PROJECT TITLE	MODWASH		DRAWN BY:	
	2600 JUAN TABO BLVD. NE		DTN	
	ALBUQUERQUE, NEW MEXICO 87112			
PROJECT MANAGER	JOB NO.			
DEVIN NGUYEN	Modwash - Juan Tabo			
SHEET TITLE	OVERALL SITE PLAN

DATE: 20 Jan 2023	sheet- AS100
SCALE: AS NOTED	of-

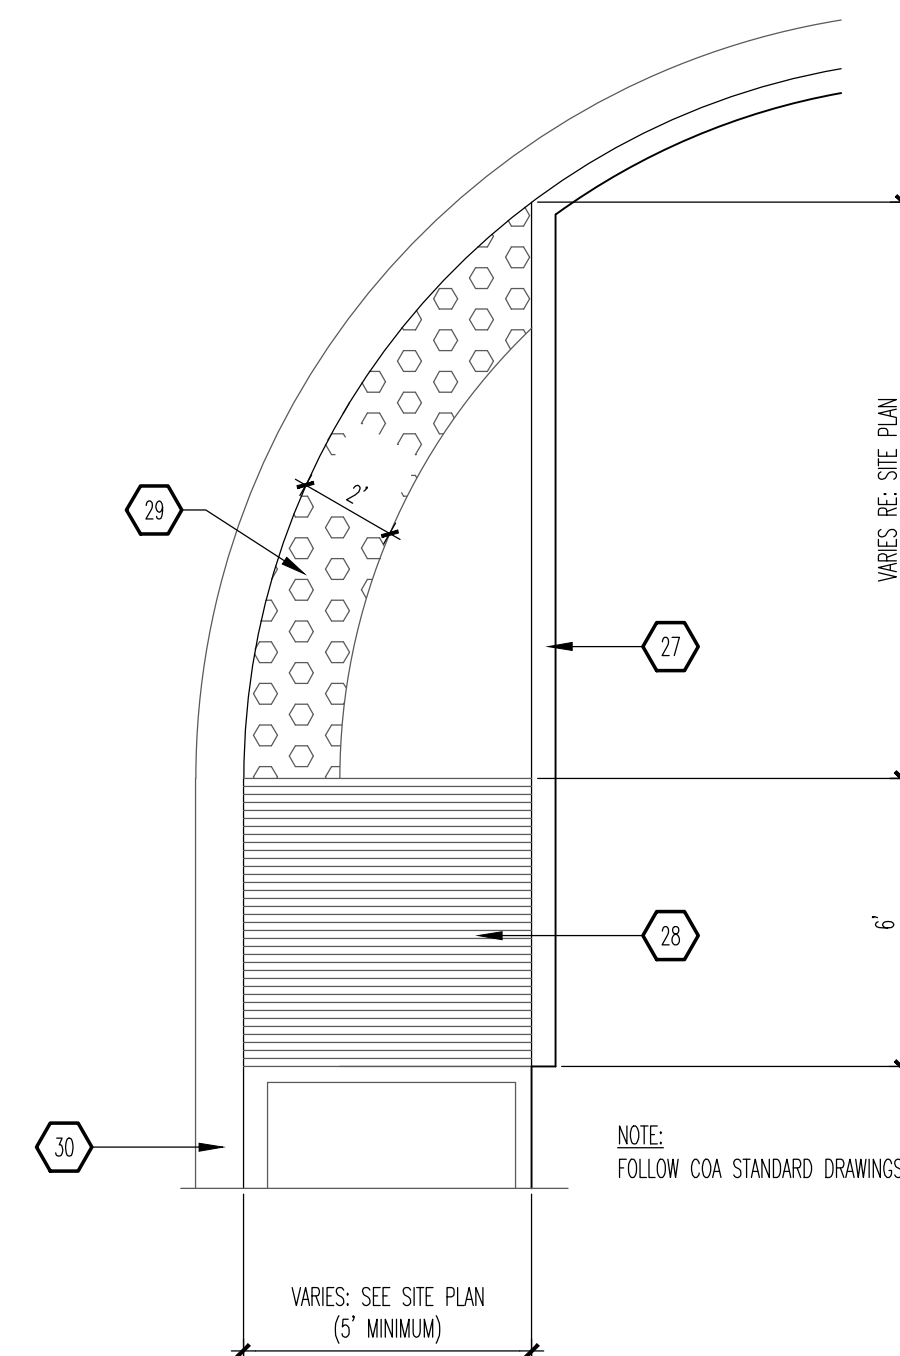
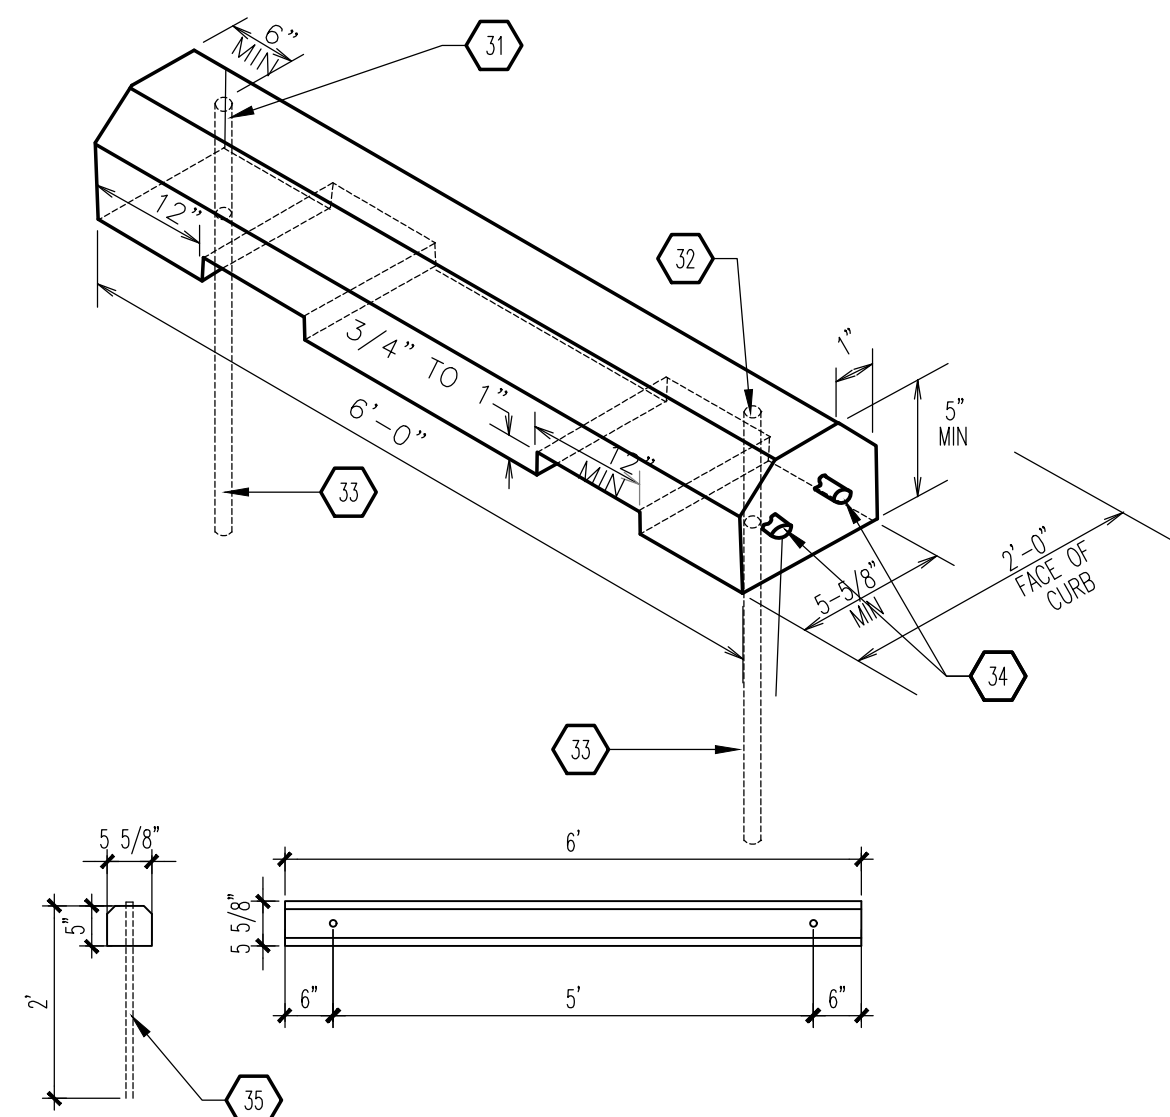
Approved w/condition for access by the Solid Waste Department for a single trash enclosure. Herman Gallegos 02-16-23.

****Condition****The owner will make the entry on Juan Tabo a shared access when they subdivide the property, or this approval for access will be void.*Herman Gallegos*
